## ZONING BOARD OF ADJUSTMENT PUBLIC HEARING CITY OF FAIR OAKS RANCH, TEXAS October 12, 2022

AGENDA TOPIC: The Zoning Board of Adjustment of the City of Fair Oaks Ranch, Texas, will conduct a public hearing to receive public testimony on the Variance Application No. ZBOA 2022-10-12 from Ms. Carmen Groth, applicant, on behalf of the property owner, G Leon Family Partnership LTD to grant variances for the property located at 28313 Leslie Pfeiffer Drive, Boerne, TX.

Figure 7-16 Illustration showing required Street Screen along all frontages with surface parking in the setback zone.

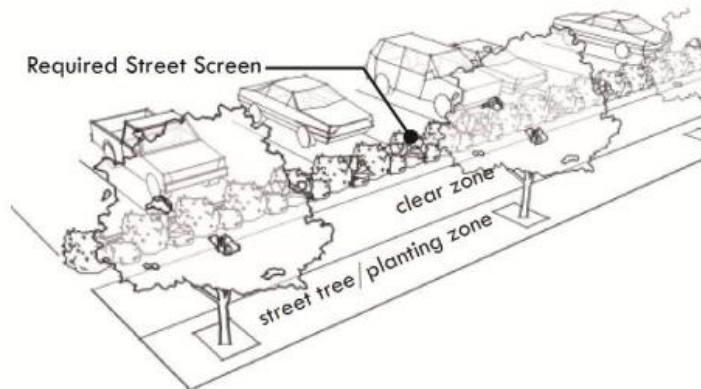
1. A 25 foot wide landscaped strip along the street frontages, with trees and shrubs as required by **Figure 7-16 (UDC Sec. 7.7)** below.
2. Street trees: Spacing shall be an average of 30 feet on center. The minimum caliper size for each tree shall be 2 inches and shall be a minimum of 8 feet in height at planting. Each tree shall be planted in a planting area no less than 36 sq. feet. Species shall be native or adapted species selected from the Approved Plant List, found in Appendix B of the UDC.
3. Shrubs: 3-foot landscaped vegetative screen composed of shrubs planted to be opaque at maturity (see **Figure 7-16**).
4. All other landscaping requirements shall be met.

## Illustration 2: Schematic Diagram Showing Compliance (Shared with the applicant in February 2022)

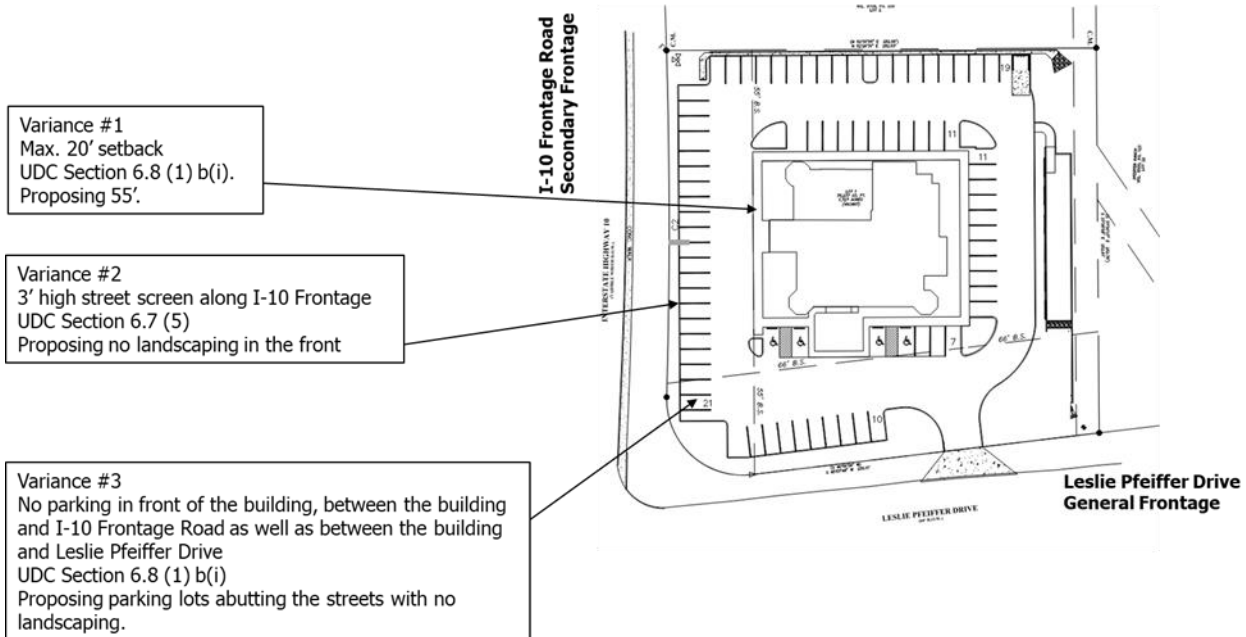
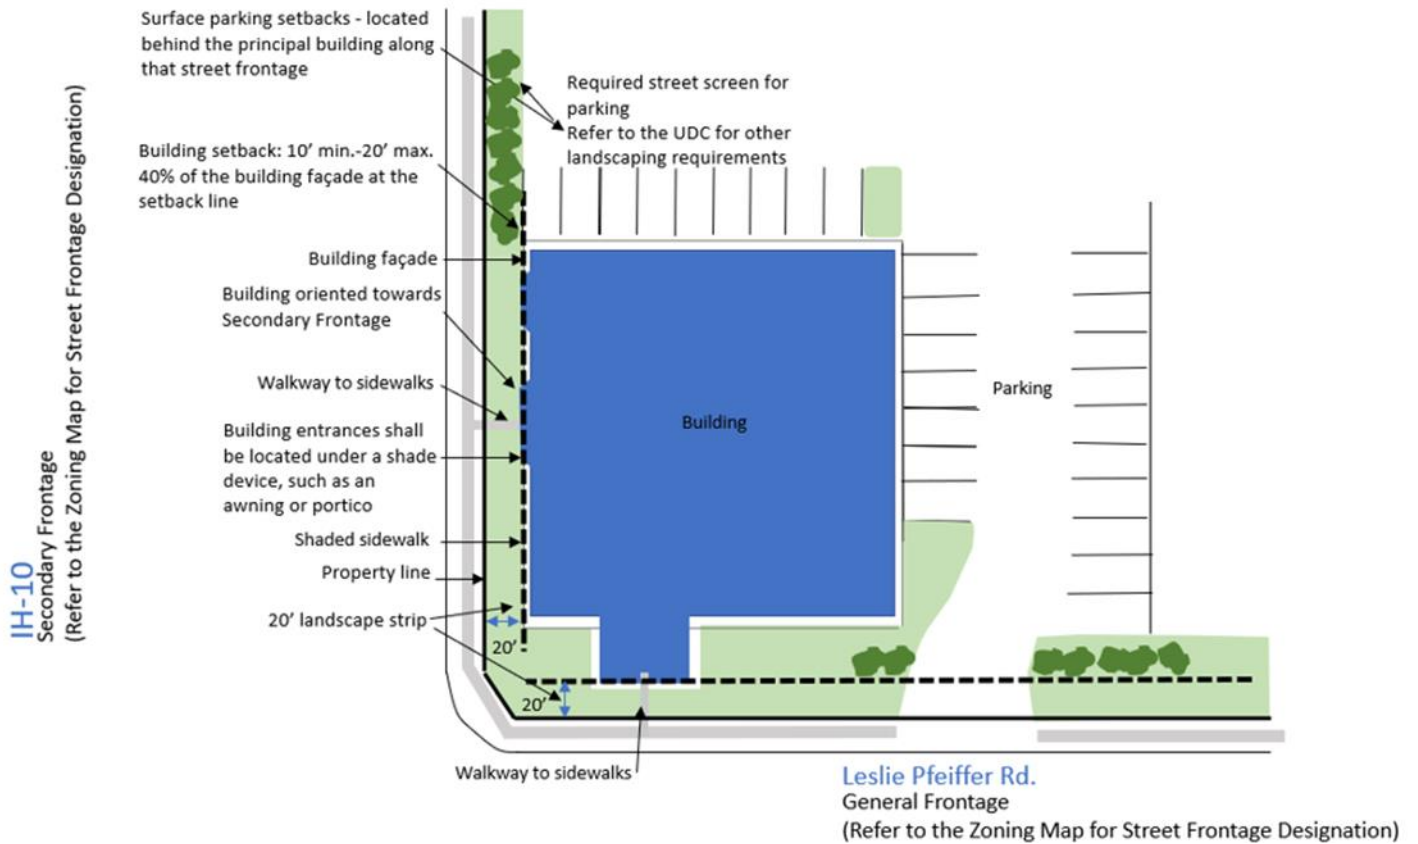
Preliminary review of the site indicates that the requirements of the UDC in terms of access, landscape screening, parking setback from the street, and number of parking spaces can be met by re-designing the layout per the **Illustration 2: Schematic Diagram** below. Staff's review of each Variance is listed below:

**Finding:** Per the **Illustration 2: Schematic Diagram Showing Compliance (prepared by staff)**, it is staff's opinion that the site can be redesigned to meet this requirement. The applicant has not identified any constraints on the property that would prevent the applicant from meeting this UDC requirement. The criteria in UDC Sec. 3.9 (9), do not apply and a deviation is not warranted. Adherence to this requirement will not prohibit or unreasonably restrict the utilization of the property.

**Finding:** It is staff's opinion that the 3' high street screen can be provided by redesigning the site to meet this requirement as shown in **Illustration 2: Schematic Diagram Showing Compliance (prepared by staff)**. The criteria in UDC Section 3.9 (9), do not apply and a deviation is not warranted. Adherence to this requirement will not prohibit or unreasonably restrict the utilization of the property. Removal of this landscaping screen will result in no landscaping at all between the building and I-10 Frontage Road, which will adversely affect the character of the area.

**Finding:** It is staff's opinion that site can be redesigned to meet this requirement as shown in **Illustration 2: Schematic Diagram Showing Compliance (prepared by staff)**. The criteria in UDC Sec. 3.9 (9), do not apply and a deviation is not warranted. Adherence to this requirement will not prohibit or unreasonably restrict the utilization of the property. Granting this Variance will be not in conformance with the purpose of the Mixed Use Village district, as stated in the UDC and Hill Country Design aesthetic.
